Fire Risk Assessment

Property assessed: 1-58 Clifford Lamb Court
Hillingdon Drive Manchester M9
7DB

Client: Northwards Housing

FRA Inspection Date: 24/10/2018
FRA Issued to Client: 30/11/2018
FRA valid to: 30/11/2019
FRA completed by: Savills (UK) Ltd,
33 Margaret Street, London W1G 0JD
T: 020 7409 8737
E: fireriskhousing@savills.com

Question - M.6: Are intumescent strips and smoke seals provided to common area fire doors? No

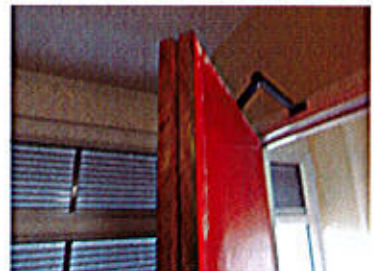
Comment: Common area fire doors are provided with adequate intumescent strips and smoke seals, except for the communal lounge door and the eleventh floor refuse chute lobby door.

Recommendation: The communal lounge fire door should be fitted with intumescent strips and smoke seals.

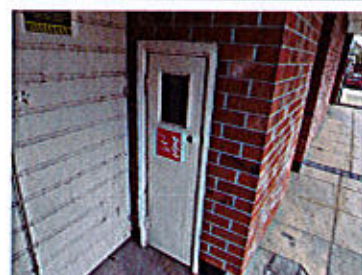
<p>Question - O.5: Are all other fire safety signs issues satisfactory? [2]</p>	No
<p>Comment: Other fire safety signs issues noted include the dry riser inlet was signed as an outlet.</p>	
<p>Recommendation: The dry riser inlet should be signed as such.</p>	
<p>Priority: C</p>	<p>Known Quantity: 1</p>
<p>Potential Quantity: N/A</p>	<p>Action ID: 107847</p>
